Application for Licence Amendment

Licence Number	L9395/2023/1
Licence Holder	Mindarie Regional Council
File Number	DER2023/000416
Premises	Tamala Park Waste Management Facility 1700 Marmion Avenue CLARKSON WA 6030 Legal description – Being part of Lot 9020 on Plan 408820 as depicted in Schedule 1.
Date of Report	16 July 2024
Decision	Revised licence granted

This Amendment Report documents the assessment of potential risks to the environment and public health from proposed changes to the emissions and discharges during the construction of perimeter drainage swales, culvert and surface water pond, in conjunction with the Stage 2 capping works on the premises. As a result of this assessment, revised licence L9395/2023/1 has been granted.

Figure 1: Surface water catchment area

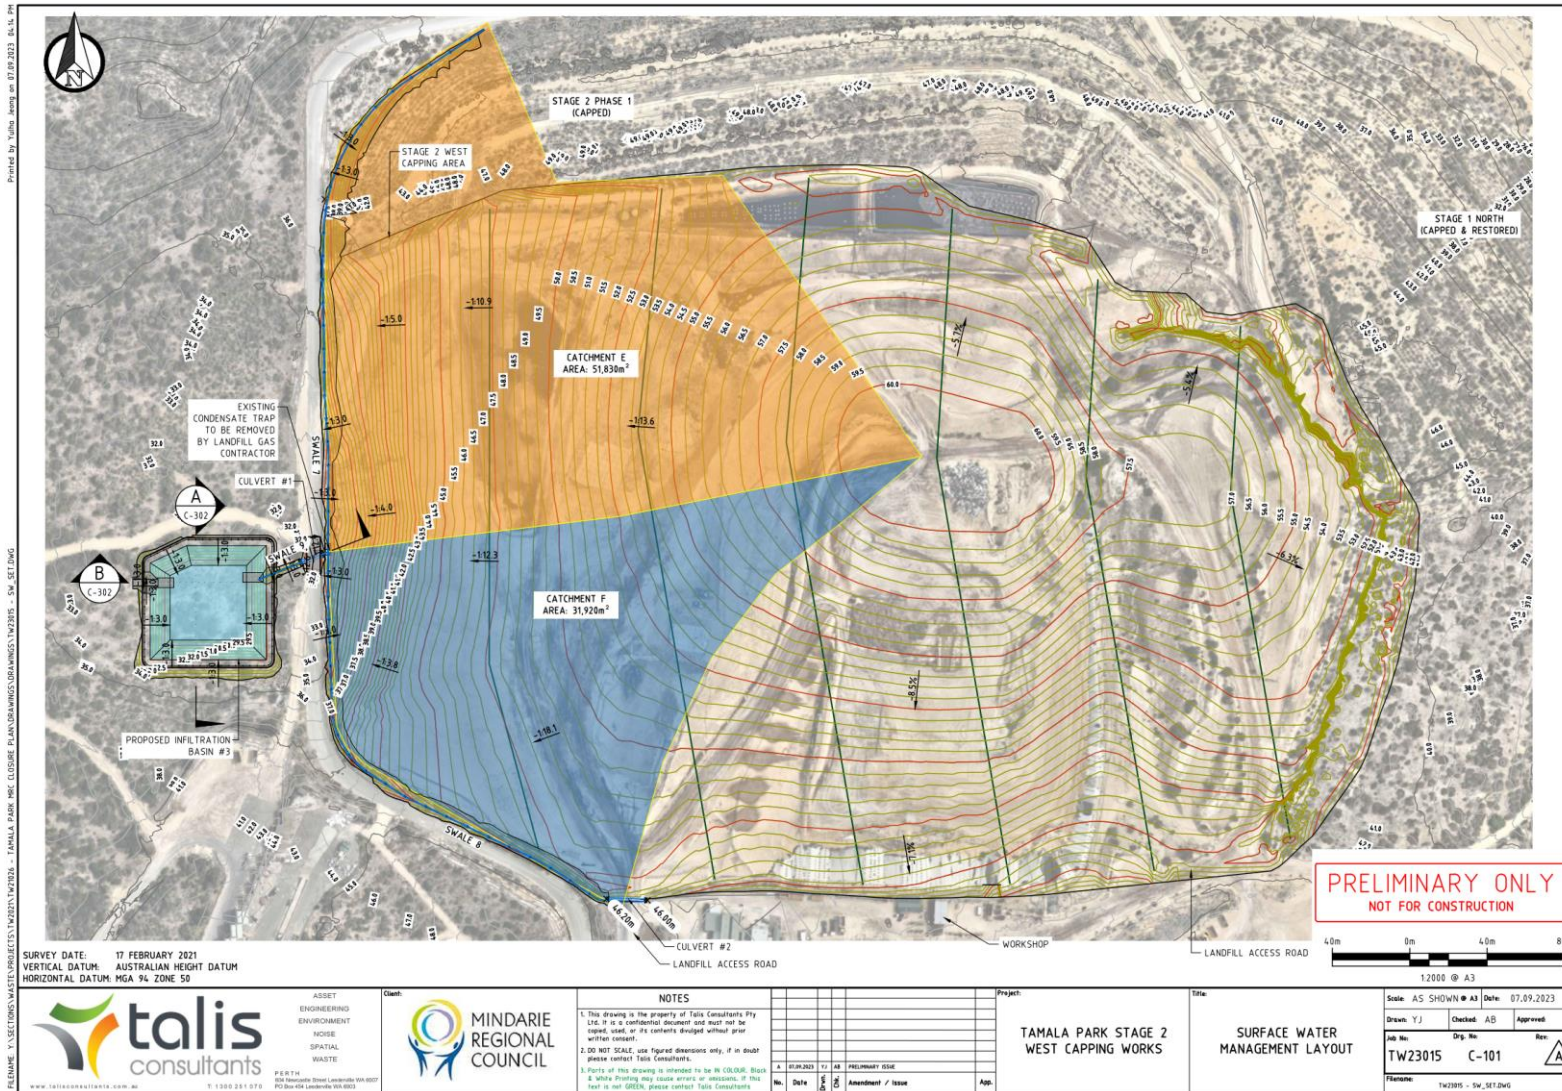
The applicant has re-configured the originally proposed catchment design to incorporate catchment area E to join with catchment area F at the landfill peak with a combined catchment area of 83,750m² (Figure 1). The pond covers a surface area of approximately 59m x 60m giving a surface catchment area of 3,540m²

- Rainfall capture on catchment areas E, F and the infiltration pond surface (87,290m²).

The basin has been sized to accommodate a maximum 1 in 100-year, 24-hour storm event within its full capacity as highlighted in yellow in Table 2. Should the basin overtop due to any greater storm event, the pond design will allow for a controlled release of stormwater into the environment away from the capped landfill area via a 200mm notched weir to protect the pond walls integrity.

The Delegated Officer considers the stormwater infiltration basin and associated drainage infrastructure design has been sized appropriately with consideration of local climate data including rainfall depth and intensity.
